response to IFB #20-0811 Clarke County

Courthouse: HVAC Renovations

#### ADDENDUM # 001 for IFB #20-0811 Clarke County Courthouse: HVAC Renovations

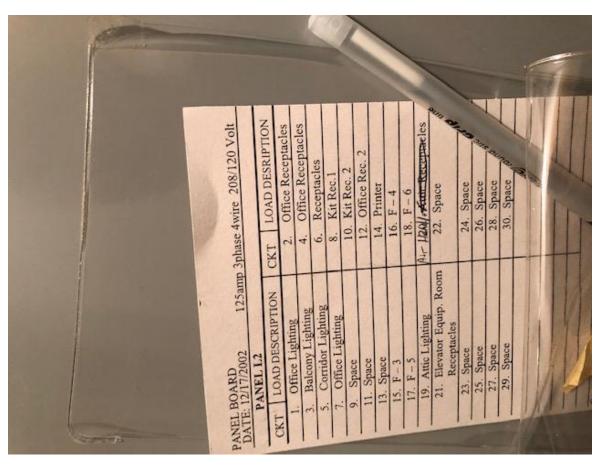
Note 2: One pages 2-4 of this addendum are pictures of the breaker panel for the indoor units in the attic. This panel is L2 located in the room that would not open during the mandatory pre-bid meeting. We notified vendors in attendance that we would post these pictures in the first addendum.

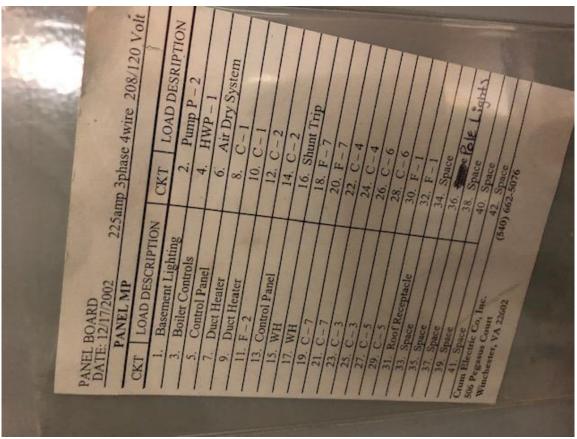
Note 3: One pages 5-6 of this addendum are pictures of the panel for the outdoor units (Panel MP). This panel is located in the Fire Pump room just below the location of the outdoor units on the roof. Contractor verification will have to be performed. Our Maintenance Department is not sure if C3, C4, and C5 match F3, F4, and F5.

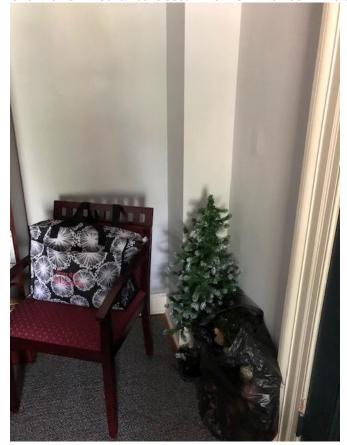
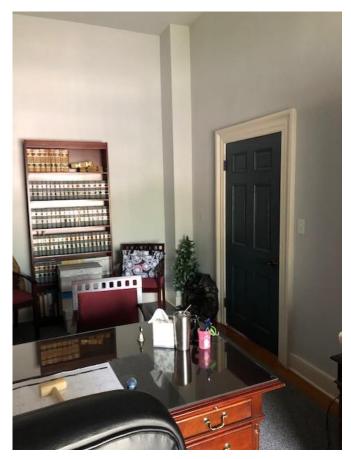
Note 4: One pages 7-9 of this addendum are pictures of the new proposed condensate run. The two pictures on this page show a case in the corner of the new mechanical closet. The line will run down the chase.

This picture shows the same crawl chase on the first floor. The line will continue through this chase to the crawl space below.
